**City of Redmond**  
**Request for Additional Information**

**SUBJECT: 2<sup>nd</sup> Request for Additional Information:  
 Ellsworth 8-Lot Short Plat, File LAND-2014-01966  
 SEPA File Number SEPA-2014-01967**

**TR-01**  
 SHEET 5 OF 6

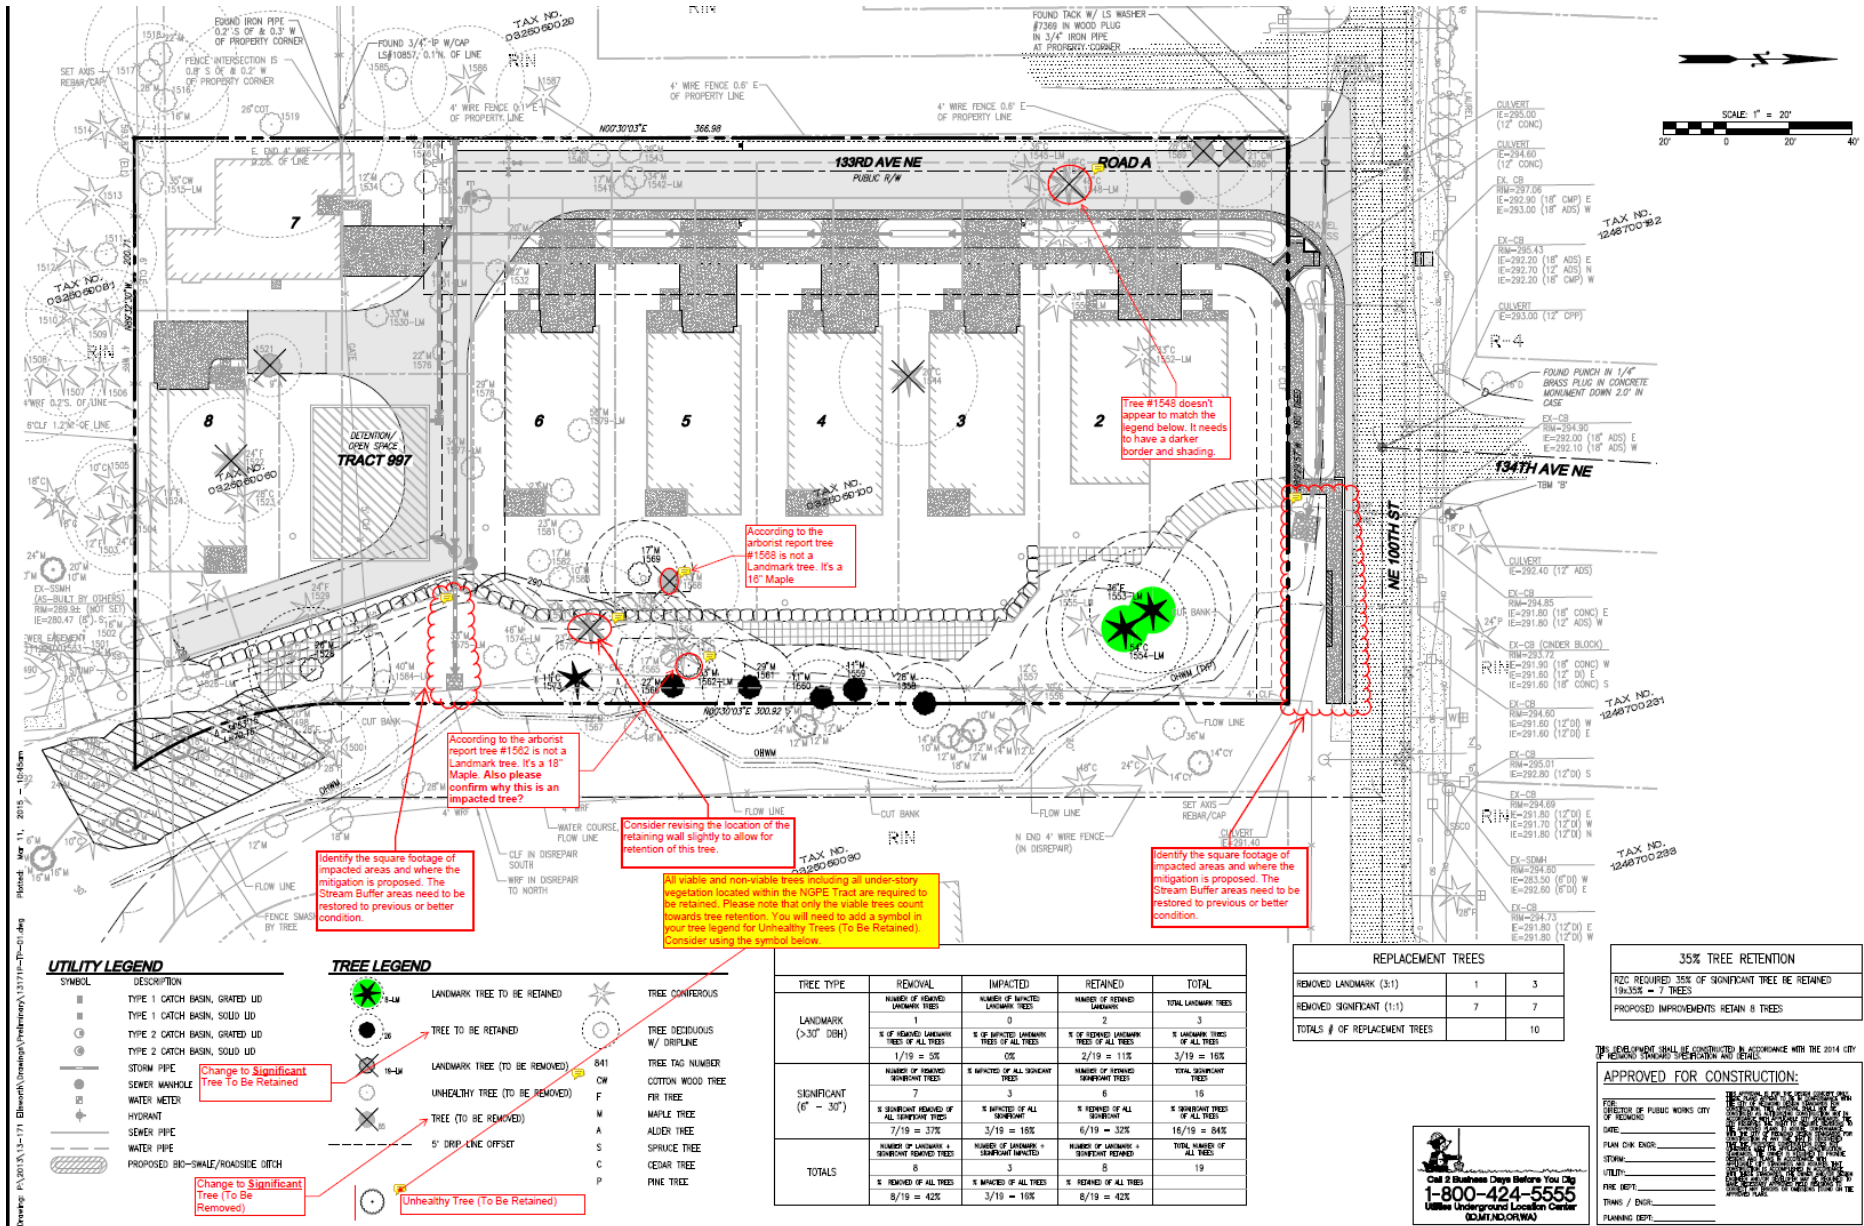
- f) The Tree Preservation Plan needs to be revised to show all existing non-viable and viable trees to be retained and all existing groundcover to be retained within the stream buffer areas. Tree #1568 is shown as a landmark tree on your Tree Preservation Plan but it appears to be a 16” Maple and Tree #1562 is shown as a landmark tree but it appears to be an 18” Maple according to the arborist report.

**Please refer to my red lines shown on the Tree Preservation Plan at the end of this letter.**
